DRAFT Working Example

Electric Generating Plant Units 1 & 2

Integrated Assessment for External Flooding

Comment [NRCstaff1]:

Figure 6-1 Elevation View of Units 1 & 2 Power Block Building (entry-way detail)

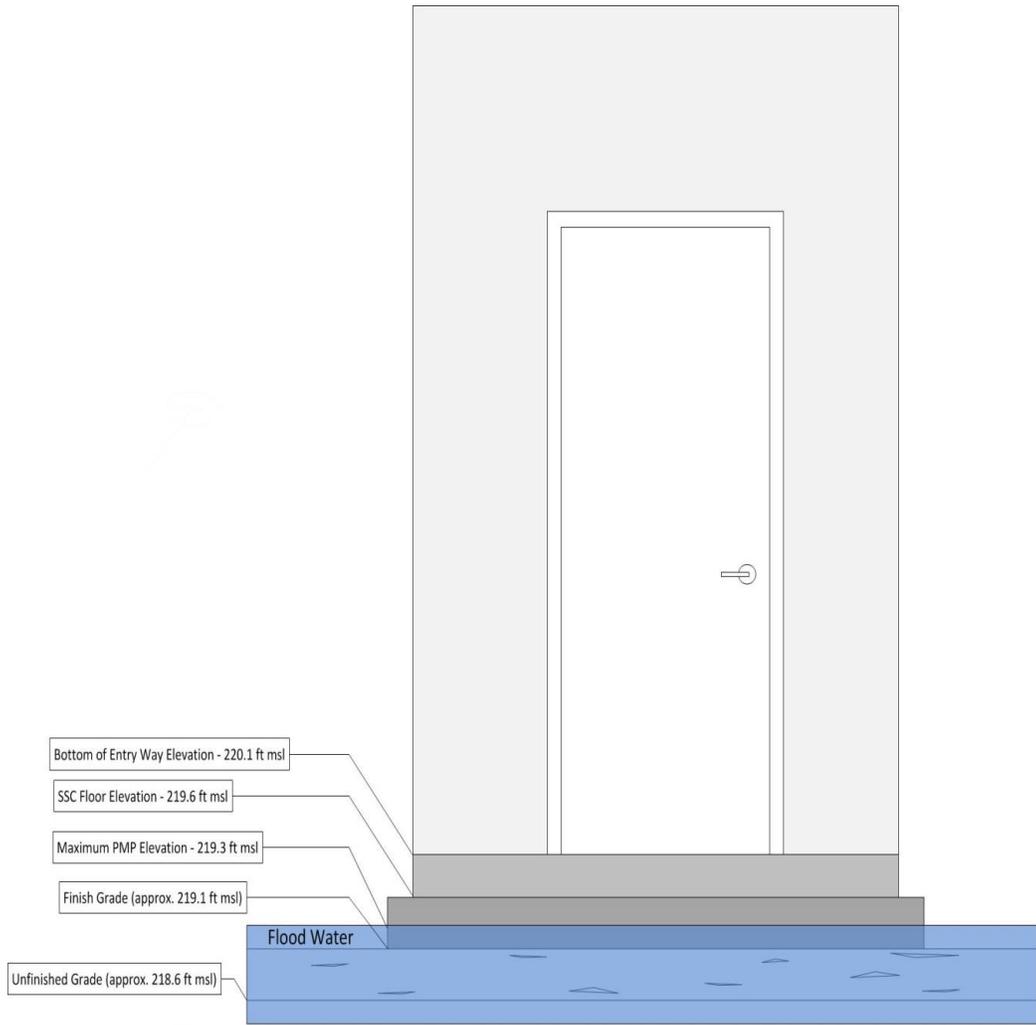
Comment [NRCstaff37]: Editorial: The paragraph below and the figure show the bottom of entry ways at 220.1

Comment [NRCstaff39]: Editorial: Consider the following format for conveying this information (e.g., using standard symbols for WSE):

Entry Way Elevation (220.1 ft)

SSC Floor Elevation (219.6 ft)

PMP (219.3 ft)

Finish Grade (219.1 ft)

Unfinished Grade (218.6 ft)

Figure 7-1 Elevation View of Units 1 & 2 Subsurface at Power Block

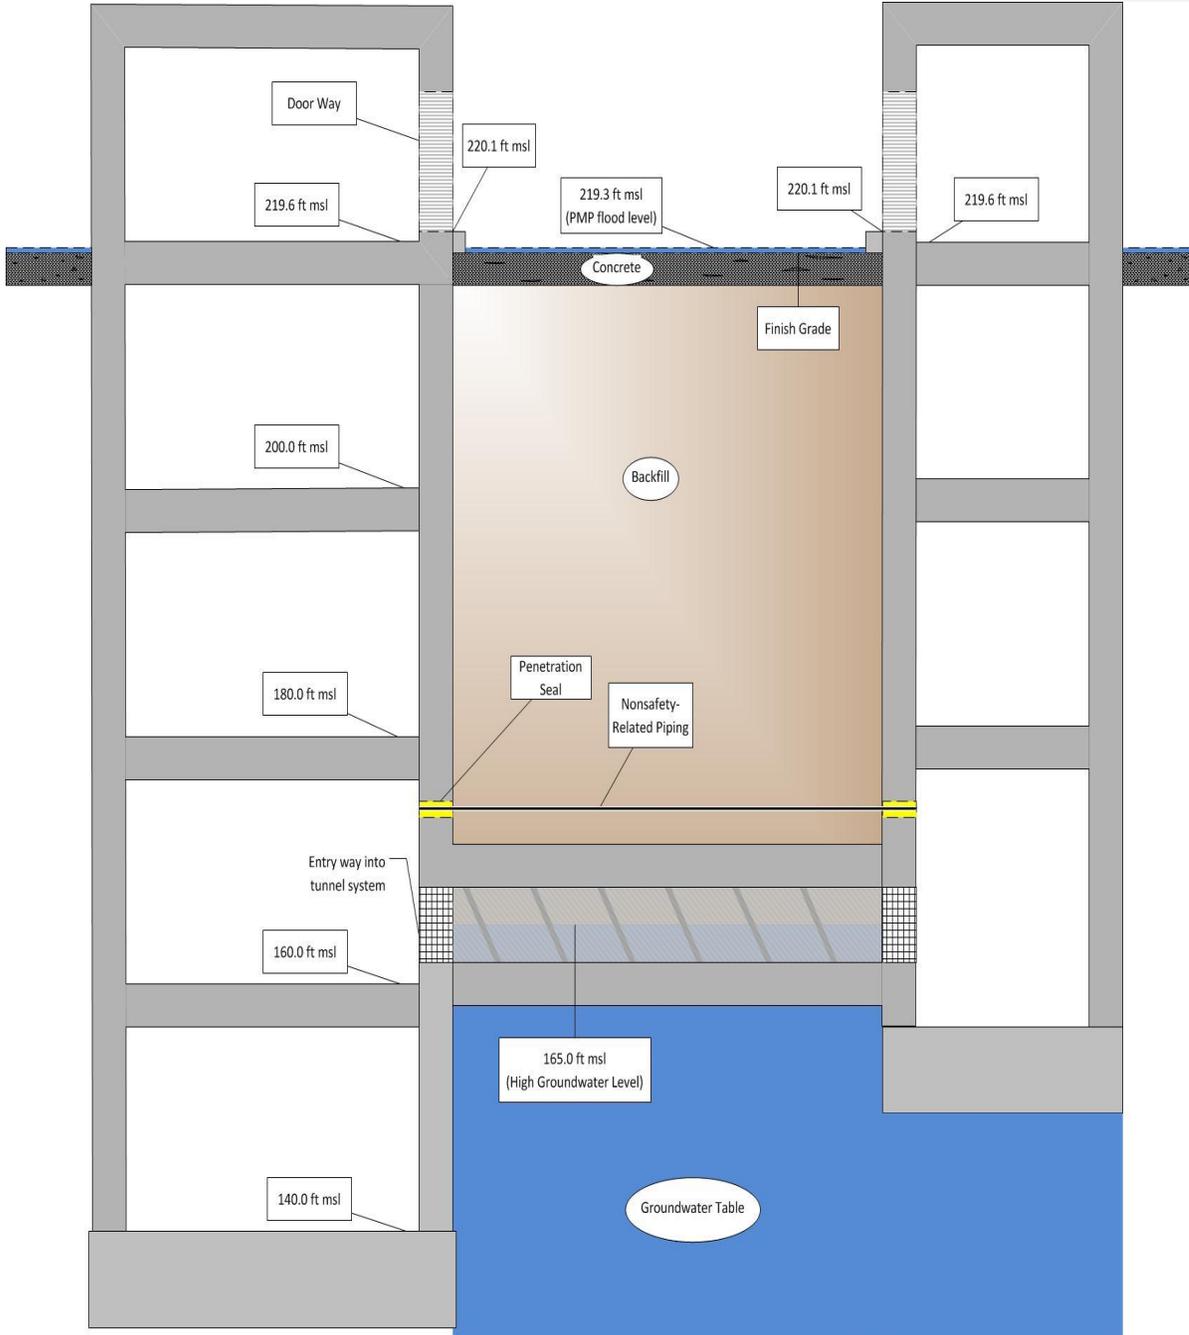
Comment [NRCstaff46]: Editorial: Consider using standard symbols for depicting the (normal) groundwater table to show the interface between saturated and unsaturated zones.

Comment [NRCstaff47]: Suggestion: Show the location of waterstops in this figure.
